AIO® Gen 1 and Gen 2+ Wall Mounted Units

Summary Of Differences

This document outlines the key technical and installation differences between our Generation 1 (Gen 1) vs. Generation 2 (Gen 2) and Generation 3 (Gen 3) AIO® Wall Mounted heat pump units. These differences primarily impact system design, connectivity, compatibility, and installation flexibility.

Figure 1. **Gen 1** Display:

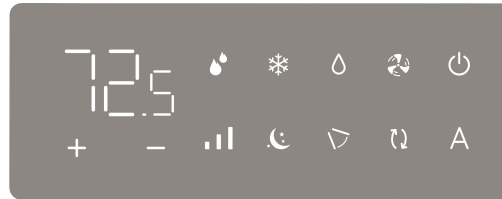
- Gen 1: Utilizes the original Gen 1 onboard touch controller interface.
- Gen 2 / Gen 3: Feature an updated onboard touch controller with improved interface and functionality.

Figure 3. **Gen 1** PCB Boards

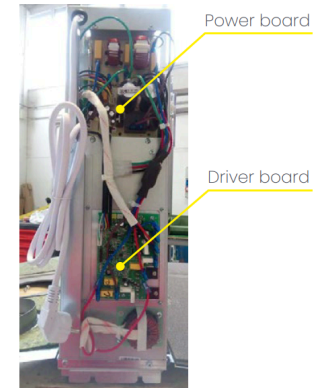
- **Gen 1:** Uses separate boards for driver, power, and MCU functions
- **Gen 2 / Gen 3:** Incorporate a redesigned, fully integrated PCB combining:
 - Driver board
 - Power board
 - MCU board

Figure 5. **Gen 2** Accessory connection locations

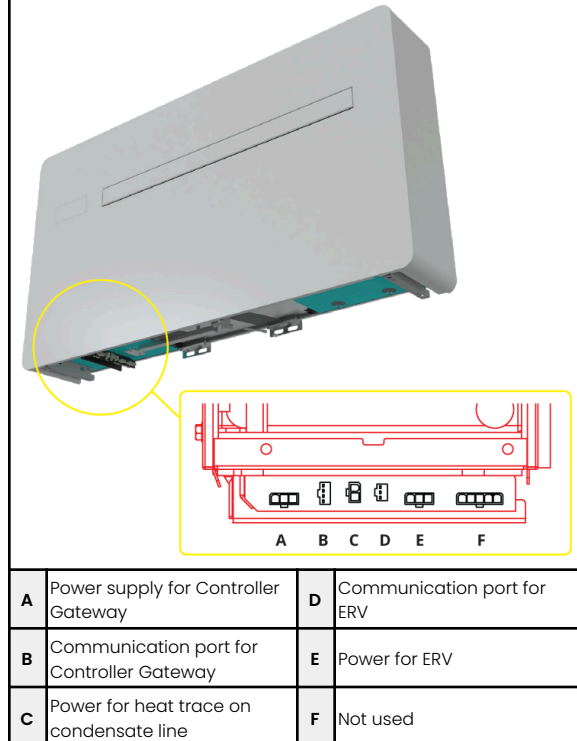
- **Gen 1:** Does not include standardized accessory connection points.
- **Gen 2 / Gen 3:** Include a block of Molex connectors for accessories that is accessible from either the bottom or side of the unit (see locations in Figures 3 and 4). This block simplifies installation and accessory integration.

Figure 8. **Gen 1** Wi-Fi chip location

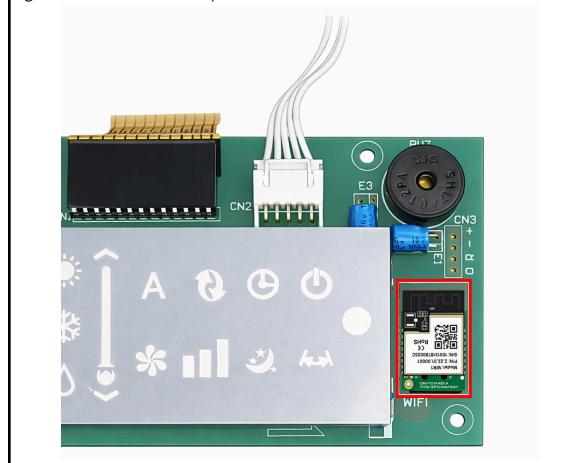
- **Gen 1:** The built-in Wi-Fi chip is located on the onboard touch controller.
- **Gen 2 and 3:** The built-in Wi-Fi chip is located on the integrated PCB board.
